SITE NAME: CENTREFIELD (WEST GORMLEY)										DATE: Apr-21										WINTER NATURAL AIR CHANGE RATE 0.229										HEAT LOSS ΔT °F. 78										CSA-F280-12																													
BUILDER: ROYAL PINE HOMES										TYPE: 2007										GFA: 1662										LO# 87524										SUMMER NATURAL AIR CHANGE RATE 0.069										HEAT GAIN ΔT °F. 13										SB-12 PERFORMANCE									
ROOM USE				MBR				ENS				BED-2				BED-3				BATH																																																	
EXP. WALL				14				6				10				16				0																																																	
CLG. HT.				8				8				8				9				8																																																	
FACTORS																																																																					
GRS.WALL AREA		LOSS GAIN		112				48				80				144				0																																																	
GLAZING				LOSS GAIN				LOSS GAIN				LOSS GAIN				LOSS GAIN				LOSS GAIN

City of Richmond Hill
Building Division

REVIEWED

Building Permit #: **BP#-2021-50732**

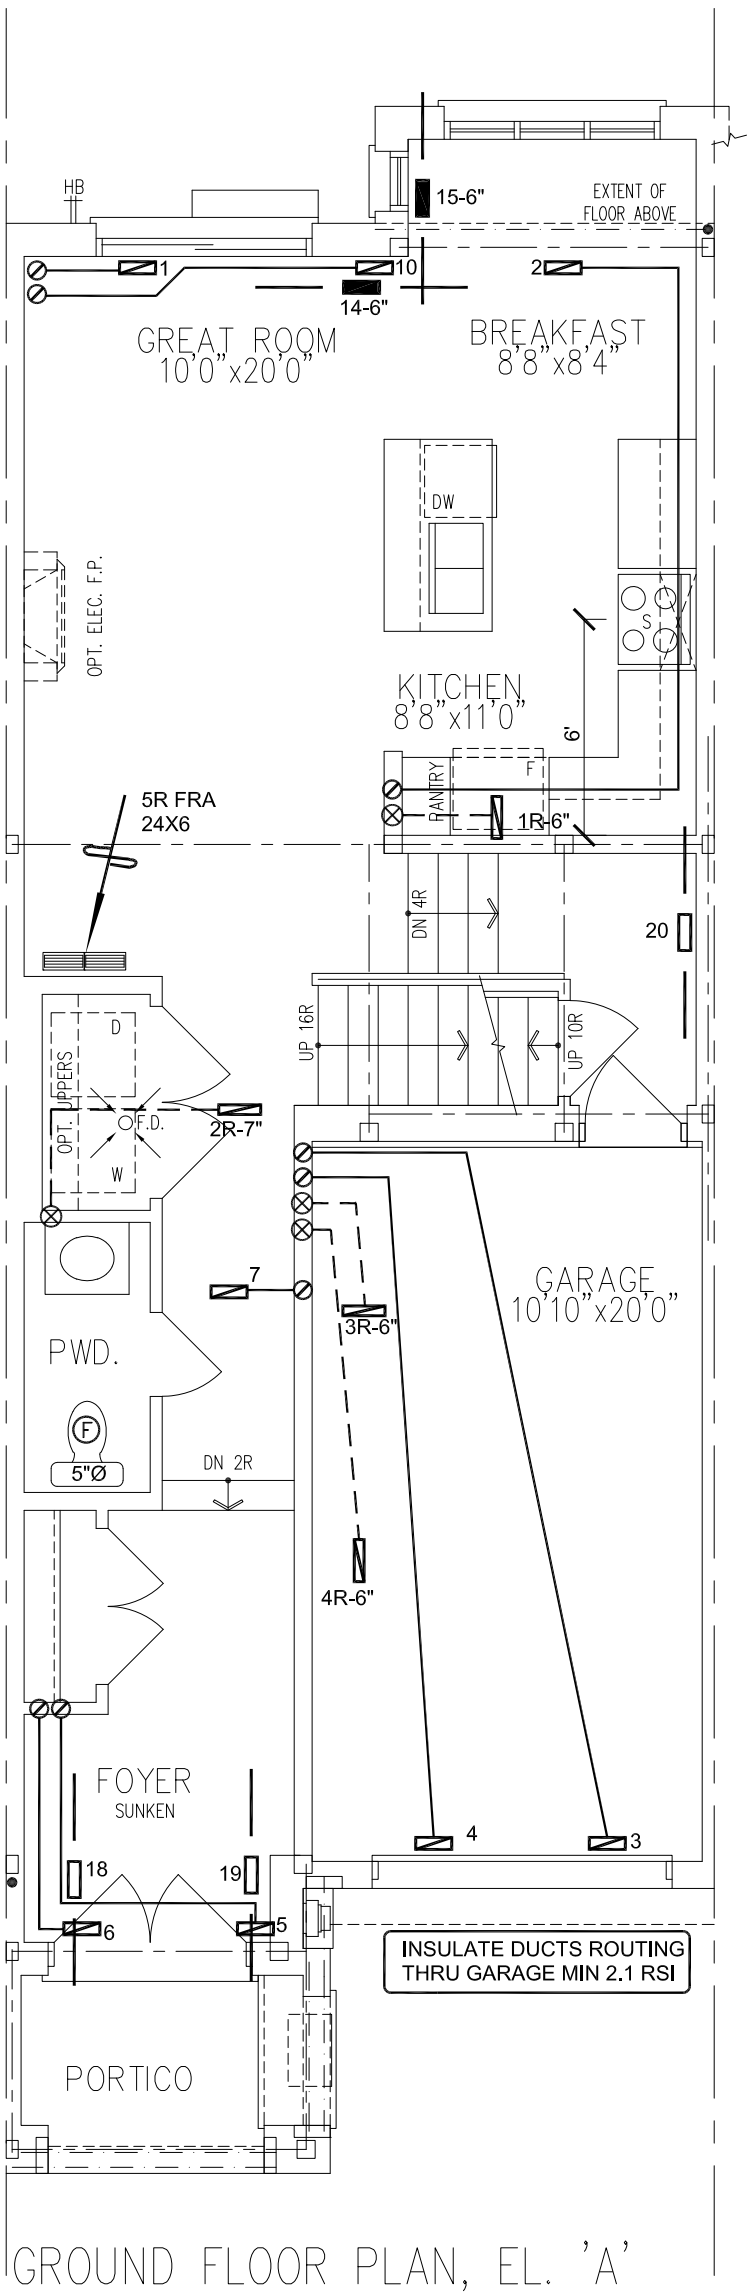
Ensure that R-Values and U-Values used for heat loss and heat gain calculations are consistent with the values specified by SB-12 Performance Compliance: **Energy Modeling/air leak test** and the values used for architectural design.

Minimum R-12 Insulation Value required for ducts installed at unheated or exposed condition (OBC 2012 Div.B 6.2.4.3(10) and seal the ducts as per 6.2.4.3(11) & HRAI Digest 2005, Clause 4.5.

Penetration of Air Barrier System by ducts, wires, conduits or building materials shall be sealed as per OBC 2012, Div.B 9.25.3.3.(9) & (10).

Volume control dampers to all branches to be installed per OBC 2012, Div.B, 6.2.4.5.

Space between studs and joists used as return ducts shall be separated from unused portion as per OBC 2012 Div.B 6.2.4.7(6)

Combustion air supply shall be provided to the furnace and hot water tank.

HRV installation, testing, startup and commissioning shall be in compliance with OBC 2012, Div.B 9.32.3.11, 9.32.3.11(7)&(10)

HRV duct connection shall be in compliance with OBC 2012 Div.B 9.32.3.6(3) & 9.32.3.4(7).

Supply air grill at finished basement shall be at low level. Return air grill for finished or unfinished basement shall be at low level. HRAI digest 2005, clause 7.7(3).

Air supply outlet shall not be installed on a furnace plenum or trunk duct. (HRAI Digest 2005, 4.6)

Exterior insulation effective R-Value for wall, roof or exposed floor shall be maintained at the respective location where duct or sanitary pipes are routed inside exterior envelope.

For simplified HRV/ERV installation, with stale air and fresh air connected to return air plenum, stale air intake and fresh air supply shall be separated minimum 3' or as recommended by HRV/ERV Manufacturer.

HRV Unit shall be energy qualified complete with sealed and insulated connection to outdoor vent hoods per Energy Star Technical Specification 4.7.1.2. When HRV is used as principal fan, the controller shall be wired to the HRV Unit and interconnected to the furnace fan. HRV shall be designed for operation at outside temperature of -25°C and a flow of minimum 30 L/s (64 CFM)

Return air intake shall be provided as recommended in HRAI Digest 2005 Section 4.7 Return air inlet should be positioned so that short circuiting of supply air is avoided. A high and low wall return air combination shall be provided when a combined cooling & heating system is installed.
